SUNDRY NOTICES AND REPORTS ON WELLS
Do not use this form for proposals to drill or to re-enter an abandoned well. Use Form 3160-3 (APD) for such proposals.

8. Well Name and No.
El Zorro A Federal #3

9. API Well No.
30-041-20834

El Zorro A Federal 3
30-041-20834
Energy Quest
February 29, 2016
Conditions of Approval

Energy Quest
 El Zorro A Federal #3
 30-041-20834
 1980 FSL + 510 FEL
 25-T85-R36E
 Roosevelt County

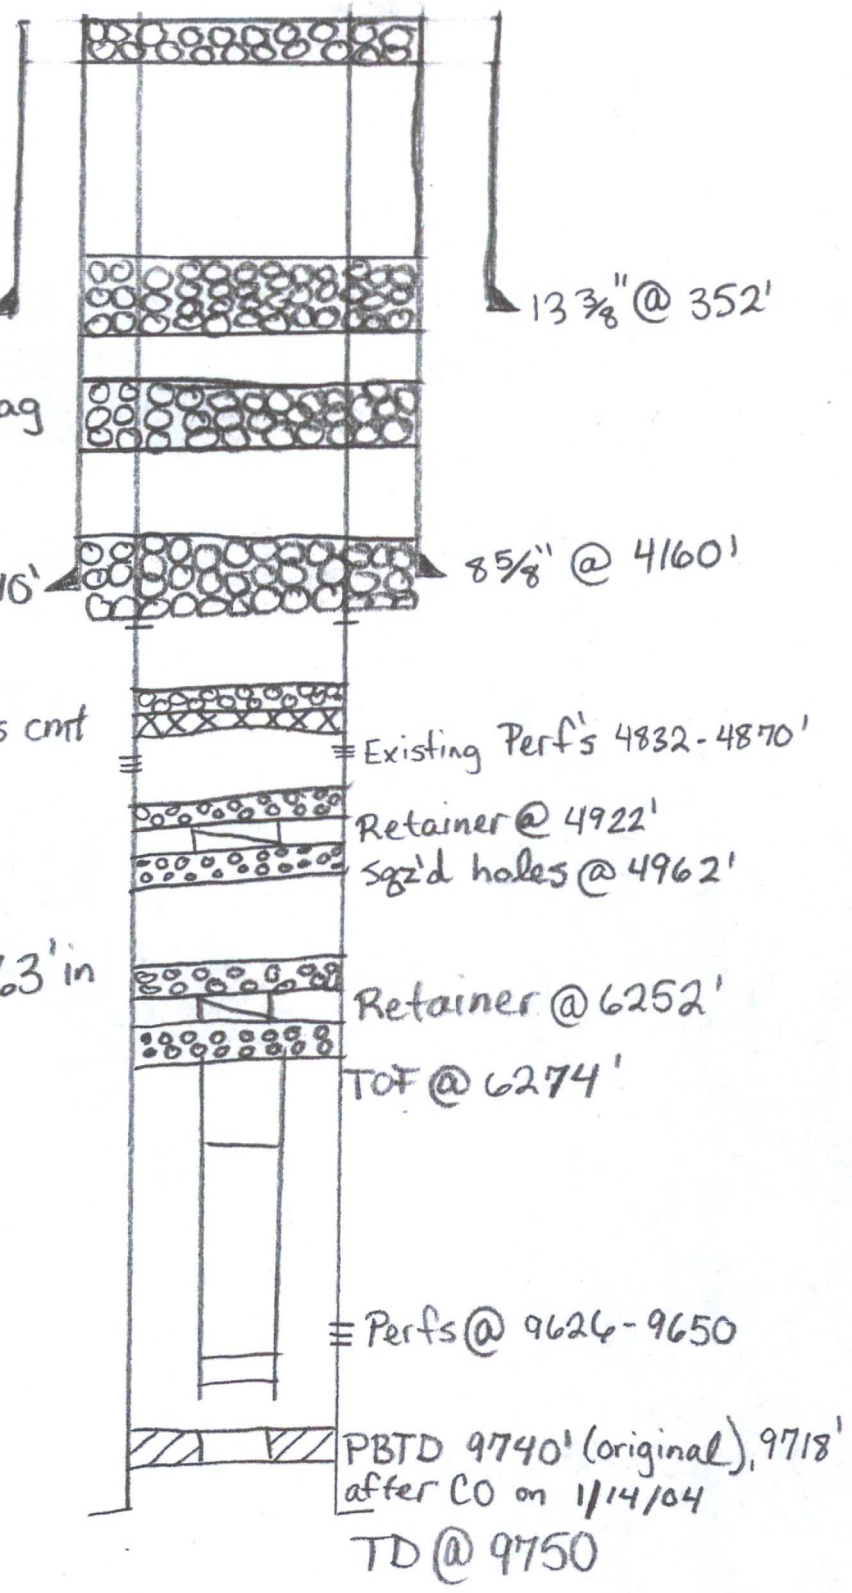
1. Operator shall place CIBP at 4,820' (50'-100' above top most perf) and place 20sx of Class C cement on top as proposed. WOC and TAG.
2. Operator shall place a balanced Class C cement plug from 4,820'-4,670' as proposed.
3. Operator shall place a balanced Class C cement plug from 4,210'-4,110' to seal the 8-5/8" shoe as proposed. WOC and TAG required.
4. Operator shall place a balanced Class C cement plug from 2,880'-2,750' to seal the Yates formation. WOC and TAG.
5. Operator shall place a balanced Class C plug from 2,400'-2,100' to seal the salt. WOC and TAG.
6. Operator shall place a balanced Class C cement plug from 600-300' to seal the 13-3/8" shoe. WOC and TAG required.
7. Operator shall place a balanced Class C cement plug from 60' - surface as proposed
8. See Attached for general plugging stipulations.
